## (1) Insights concerning "Supply lines for additional TPRDs"

## Proposal from Japan

### Cylinder Assembly – Type 3

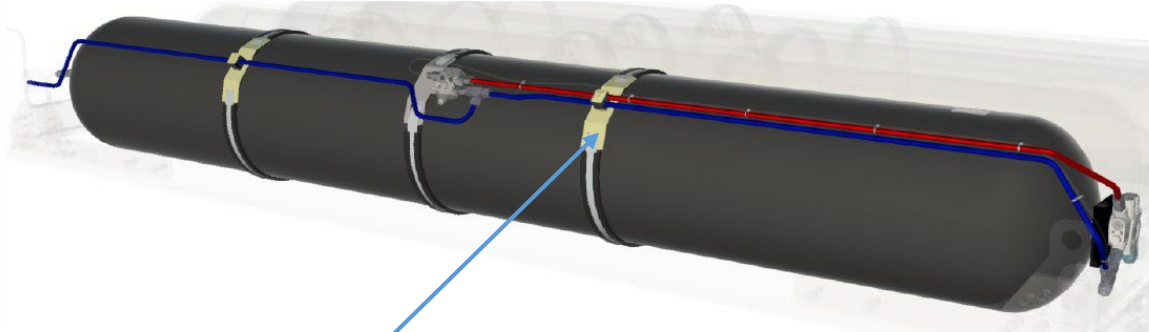
Supply and Vent lines cannot be too rigid due to cylinder expansion

This parts is considered that provide additional support and/or protection to the supply lines for additional TPRDs.

In the current proposal, this parts is not included in the definition of CHSS but may be used for each test such as Verification tests for performance durability. It is necessary to consider whether this parts should also be defined together with supply lines for additional TPRDs or not.

Regarding the parts, as we consider them to have the same functionality as a container attachment. [1]

Additionally, we are concerned that attaching the parts to the container may cause severe abrasion to the composite surface like as mounting straps. [2]

Therefore, we propose adding the following footnote to the draft definition of "Container Attachment" [1] and amending "Surface damage test" in Annex 3, Paragraph 3.3.(a) as follows [2]:

[1] "2.5. "Container Attachments" mean non-pressure bearing parts attached to the container that provide additional support and/or protection to the container and that may be only temporarily removed for maintenance and/or inspection only with the use of tools.

**Note : The non-pressure bearing parts attached to the container that provide additional support and/or protection to additional TPRDs and supply lines are also considered as container attachments. "**

If the container is to be affixed to the vehicle by compressing its composite surface **or container attachments for additional TPRDs and/or supply lines are attached to composite surface of the container**, then a second cut at least 1.25 mm deep and 25 mm long is applied at the end of the container which is opposite to the location of the first cut;"
